# CIBU connection Review

BT, BP & IRR AB/CO/MI 12December 2008

## 1<sup>st</sup> presentation: CIBU Failure in UJ33 *(Benjamin TODD)*

## 2<sup>nd</sup> presentation: Proposal cures on HW side *(Bruno PUCCIO)*

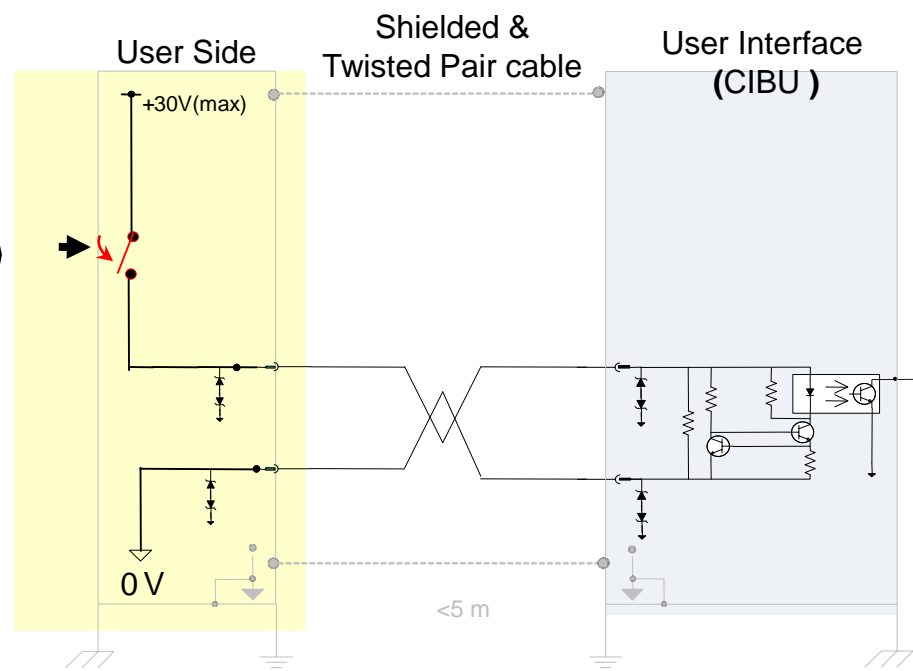
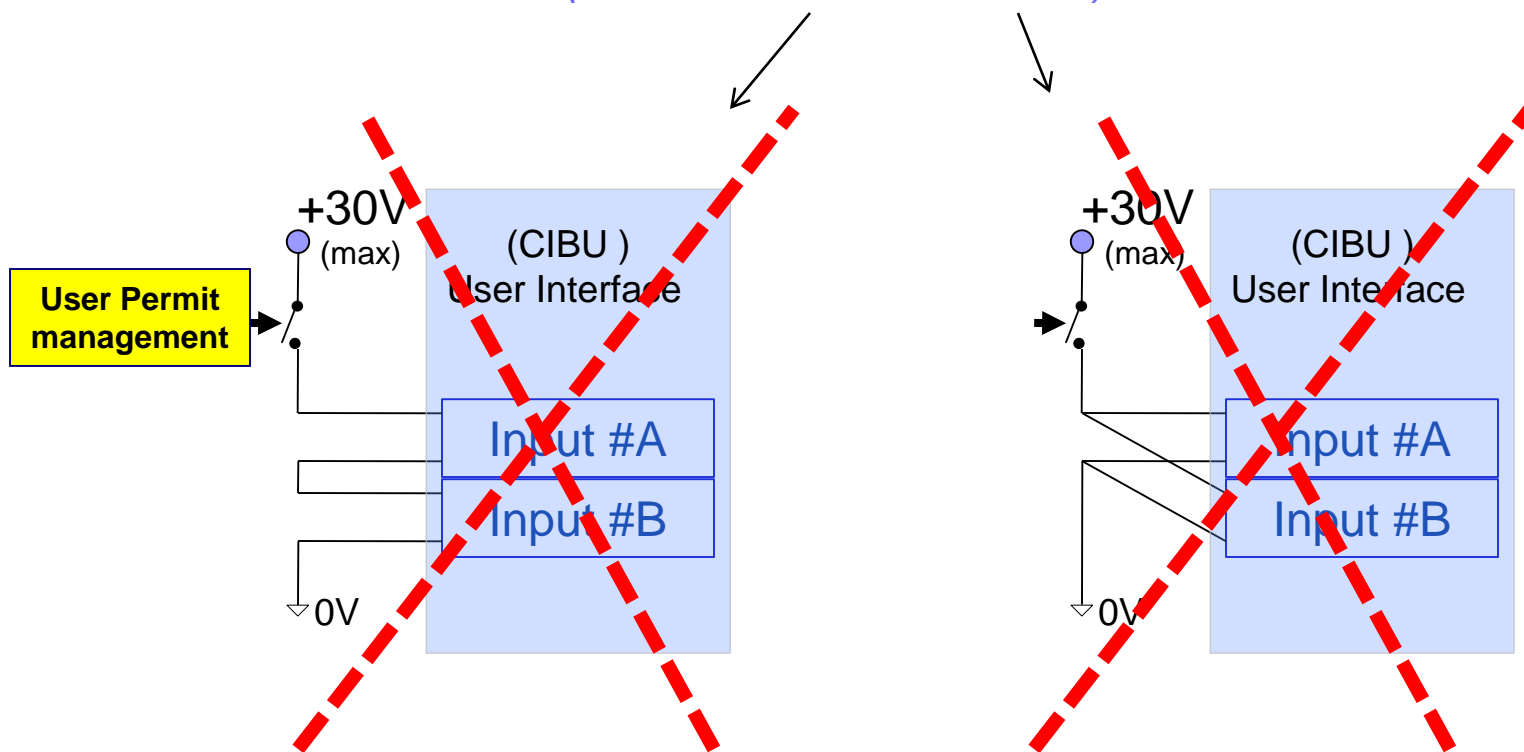
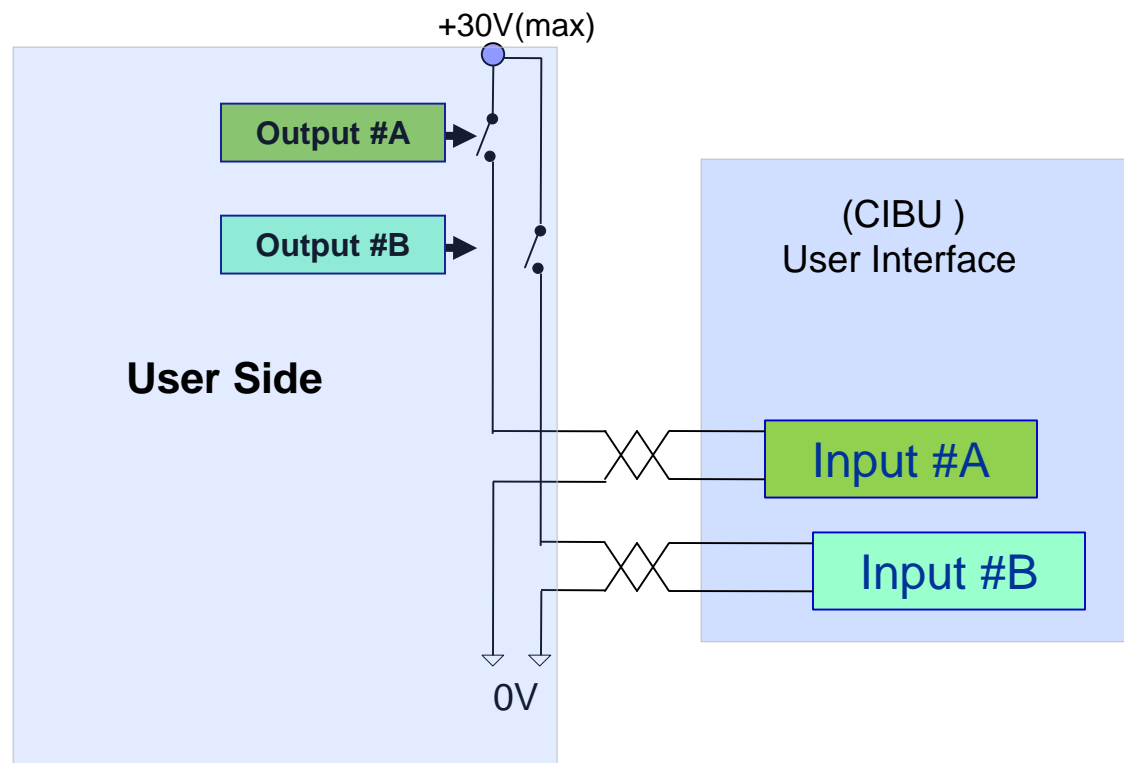
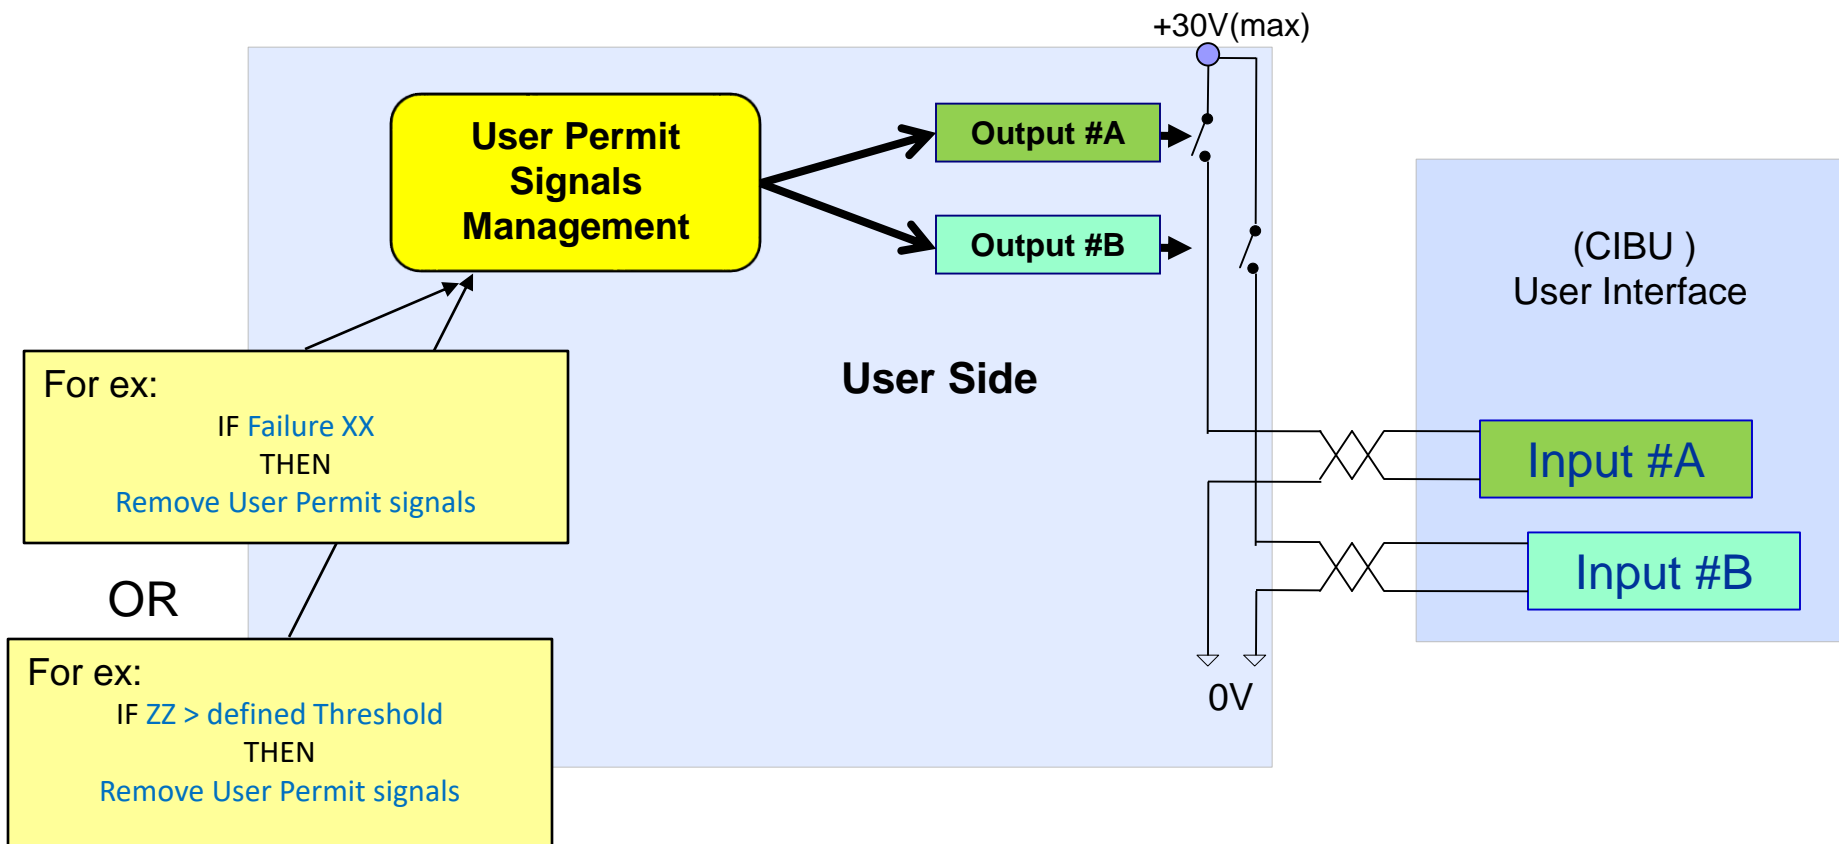
On User side, the connection should be modified in order to avoid a fail blind if GND short (i.e. a damaged TVS fuses to ground)

In order to avoid/minimize the single mode failure:  
 the two CIBU inputs should be no longer linked together  
*(neither in series nor in //)*

each User system has to provide two independent signals to the CIBU

The aim is to make two physical connections....
